SERVICE BULLETIN

NUMBER: 15-162-13

SUBJECT: Service Procedure for Replacement of the Bluetooth
 Microphone for Kenwood Audio / Navigation Systems

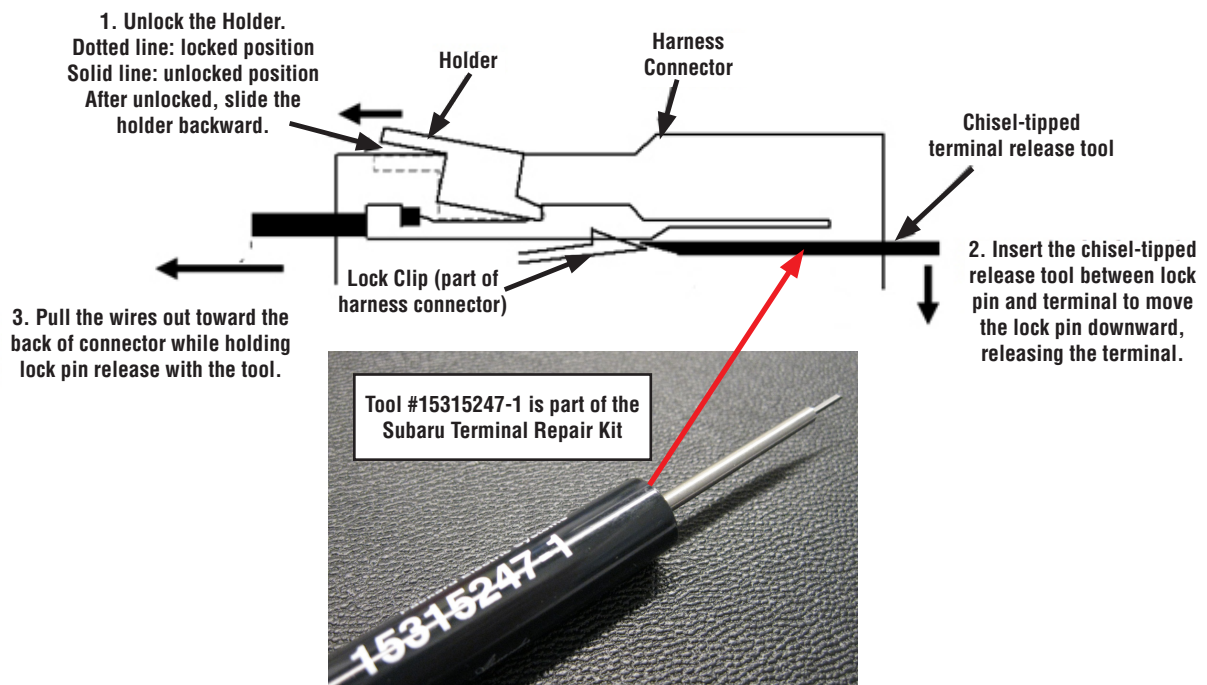
- Unlock the holder of the new microphone's harness connector. Insert a small flat-blade screwdriver under the indentation of the holder then lift up gently to unlock it as shown in the photos below. Once unlocked, slide the holder backward.

Impreza, WRX & STI

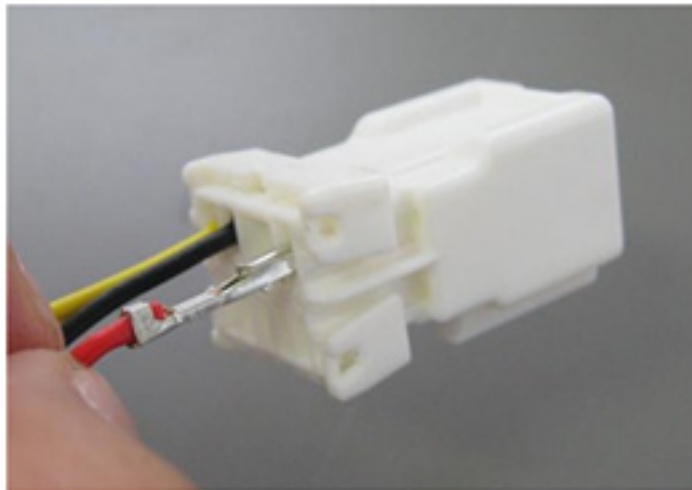
- Remove all three wires from both the replacement and the vehicle's original microphone harness connectors.
- Reinstall the terminals of the replacement microphone's harness into the vehicle's original microphone harness connector as shown below. The connector is being viewed from the front in these two illustrations.
